Projet: AP-GL-94-0007

Date: 1994-07-18

This is in response to your recent notification given in accordance with the Electricity and Gas Inspection Regulations, Section 13, regarding devices approved under:

Index covers called "lexan box assemblies" model: A-101, A-102, A-103; R-103, R-104, R-105, and R109; S-104, S-105, S-106, S-107 and its associated "Snap Seal" manufactured by Carolina Mouldings Inc. may be used in the meters approved under the above listed Notices of Approval.

Les couvercles pour indicateurs désignés "boîtes lexan", modèles A-101, A-102, A-103, R-103, R-104, R-105, et R109, S-104, S-105, S-106, S-107 et les scellés emboîtables connexes de Carolina Mouldings Inc. peuvent être utilisés sur les compteurs visés par les avis d'approbation susmentionnés.

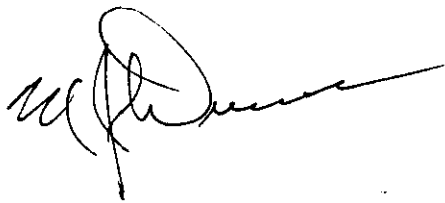
L'utilisation de ces dispositifs est également assujettie aux conditions suivantes :

- (1) Pour faciliter la vérification, le numéro de brevet É-U "4621230" ou les initiales "CMI" doivent être estampés sur chaque couvercle d'indicateur et doivent être visibles lorsque le couvercle est installé;
- (2) dans les cas où les scellés emboîtables sont utilisés exclusivement pour sceller un compteur, au moins un scellé, marqué de l'année de fabrication et de l'identification du vérificateur du compteur, doit être appliqué au point d'accès aux organes de réglage du compteur.

Après avoir étudié les modifications proposées, le Laboratoire du gaz (métrologie) me signale que ces modifications ne nuisent pas au rendement du compteur. En conséquence, les modifications sont acceptées et intégrées de facto dans les avis d'approbation susmentionnés. Tous ceux qui ont reçu l'avis d'approbation sont avisés de cette décision par une copie de la présente lettre.
